Royston Railway Station

Section 73A Report

February 2025

1.1.1 This application is made under Section 73A of the Town and Country Planning Act 1990 ('the Act') to vary Condition 4 of approved planning application 10/02085/1SU so that a previously installed public address ('PA') system can remain partially operational at Royston railway station, North Hertfordshire.

Figure 4 - Visualisation of the speaker removals/silencing at the end of Platform 2

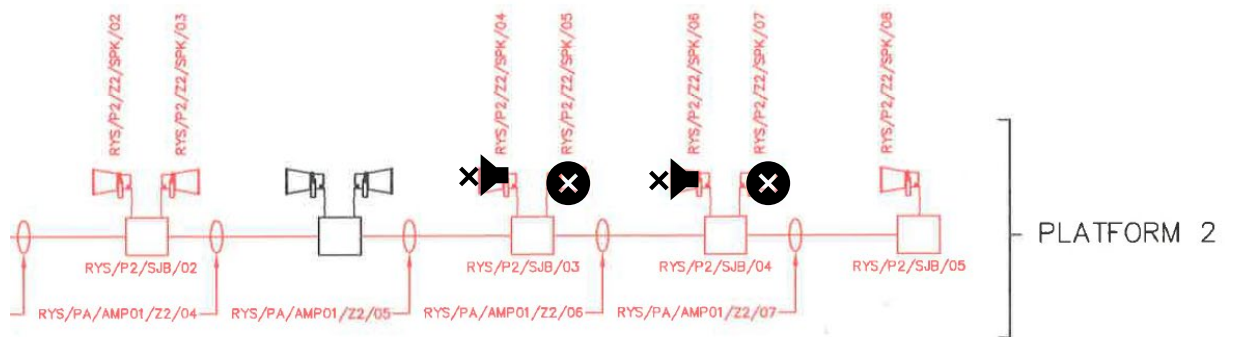
3.1.3 The Council and GTR reported complaints had been received from local residents regarding the noise generated from these speakers. As a result, GTR has undertaken the following steps to mitigate the address residents' concerns:

- Removed the existing (pre-10/02085/1SU) speaker adjacent to amplifier RYS/PA/AMP/22/05.
- Removed speakers RYS/P2//22/SPK/05 and 07.
- Turned off speakers RYS/P2//22/SPK/04 and 06.
- Limited announcements to speaker RYS/P2//22/SPK/08.
- Reduced volume levels for longline train/safety announcements.
- Reduced volume levels for roving and station mic levels.
- Adjusted the automatic gain control system (a piece of equipment which is designed to raise the longline announcement volume levels when the ambient noise is louder).

Condition 4: The existing public address system on Platform 2, including speakers RYS/P2//22/SPK/04, RYS/P2//22/SPK/06 and RYS/P2//22/SPK/08 as indicated on Drawing RYS002, dated 12/11/2020, must be set to a minimum decibel level of 65 dB(A) and not exceed a maximum decibel level of 90 dB(A) at the source for both manual and automatic announcements, in accordance with the Noise Monitoring Report undertaken by Encompass Engineering, ref: EESL-GTRN-REP-003, Revision 3 dated 20th February 2025. Removed speakers RYS/P2//22/SPK/05 and RYS/P2//22/SPK/07 must not be reinstated.
